EXPLANATION OF SIGNIFICANT DIFFERENCES

**TORCH LAKE SUPERFUND SITE
OPERABLE UNITS 1, 2 and 3
HOUGHTON COUNTY, MICHIGAN
EPA SITE ID: MID980901946**

**UNITED STATES ENVIRONMENTAL PROTECTION AGENCY
REGION 5**

October 2024

Figure 3:
Approximate Areas for Shoreline
Protection Work

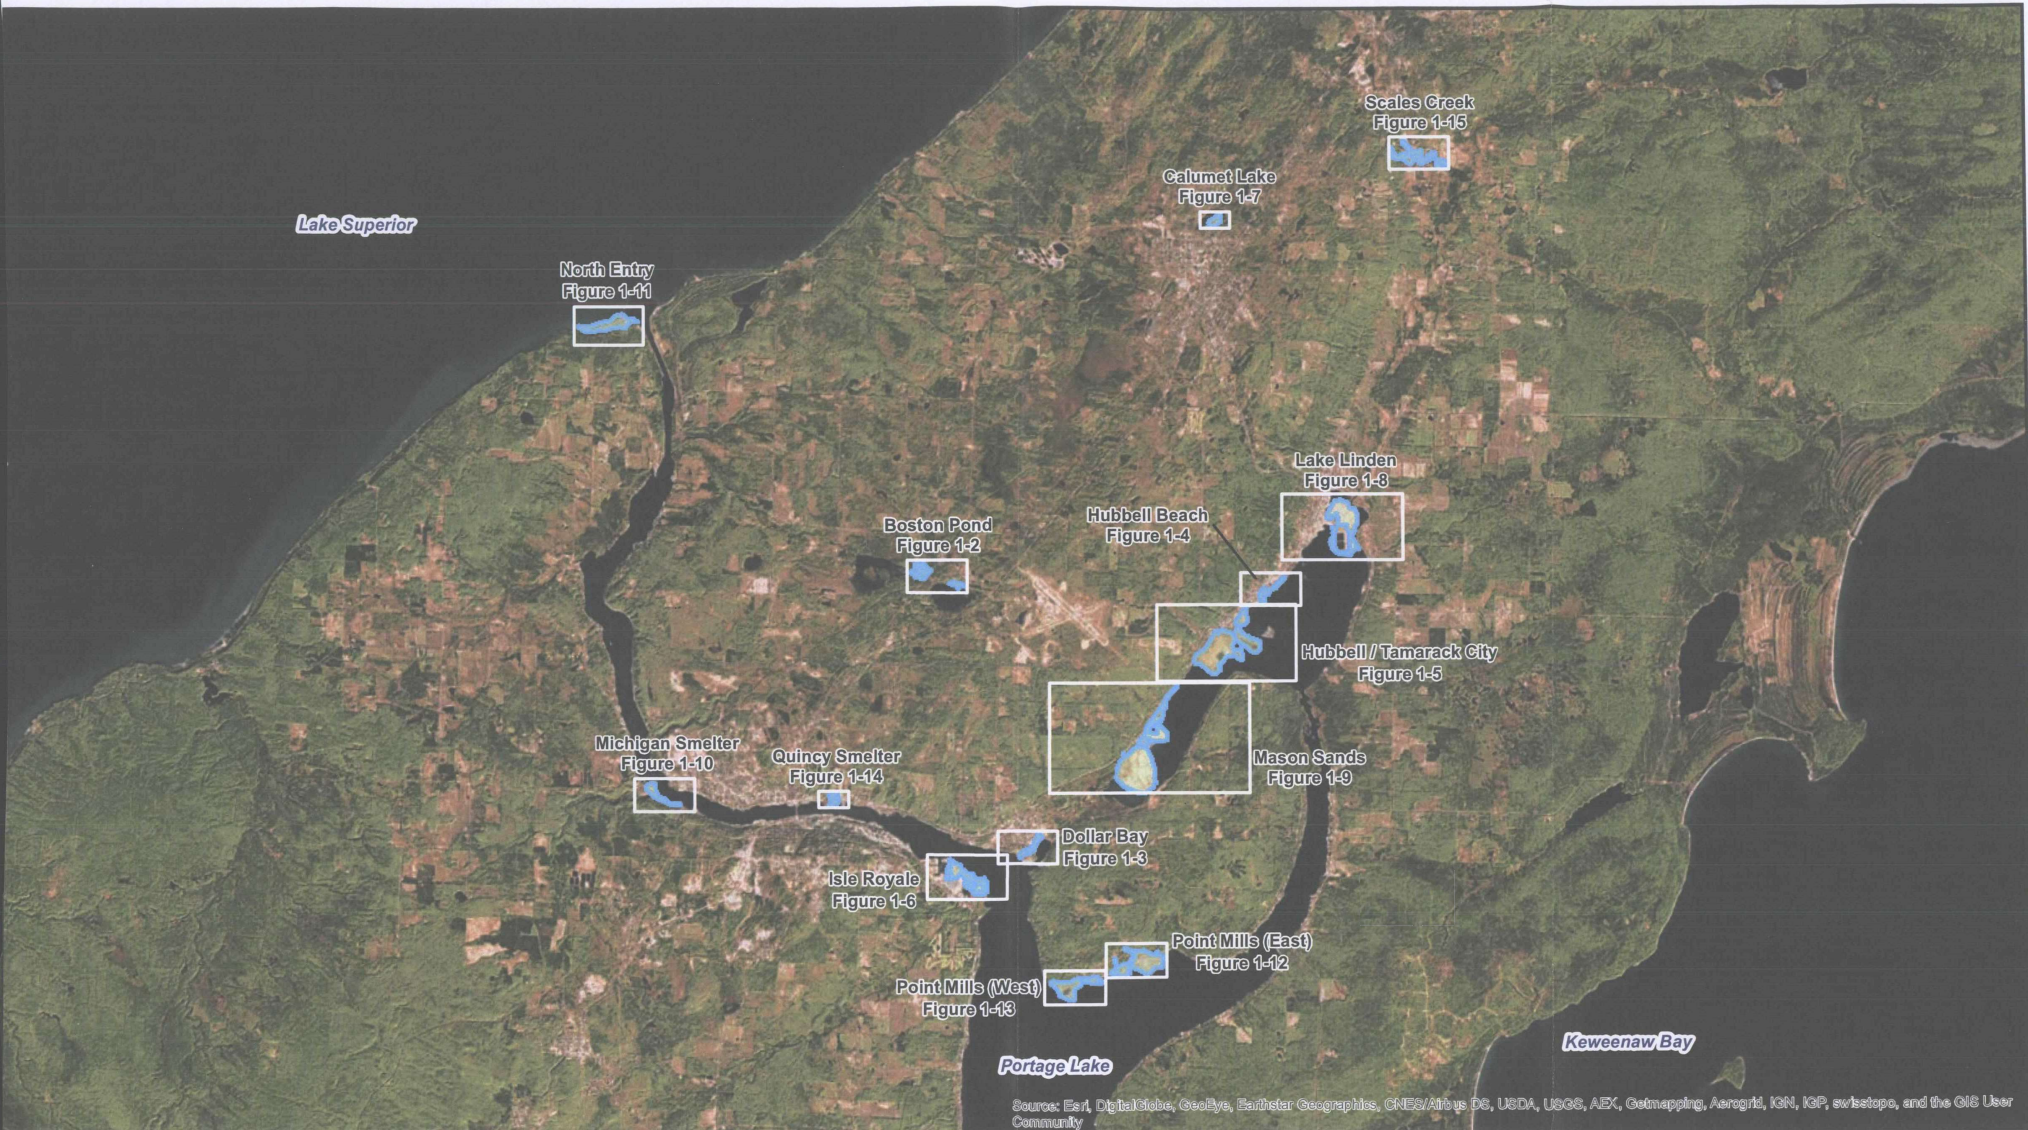
includes imagery which documents the erosion at the Lake Linden site including Figures 1&2, which illustrate the changes in the shoreline between 2011 and 2020. Since the completion of remedial action, portions of the cap are eroding, exposing stamp sands. This erosion prevents parts of the Lake Linden area from meeting one of the RAOs; specifically, the objective to reduce the release of contaminants in tailings to the surface waters and sediments through erosion. One of the purposes of this ESD is to document EPA's determination that additional shoreline protection is required in the Lake Linden area.

During the remedial design phase, shoreline protection in the form of riprap and geotextile fabrics were included for capped areas where EPA expected shoreline erosion. This ESD documents EPA's modification to the geographic scope of the selected remedy by increasing the area in Lake Linden where shoreline protection is used. Figure 3 illustrates the areas where shoreline protection is to be added and is included as Appendix C. This change will include approximately 2,000 feet of additional shoreline protection.
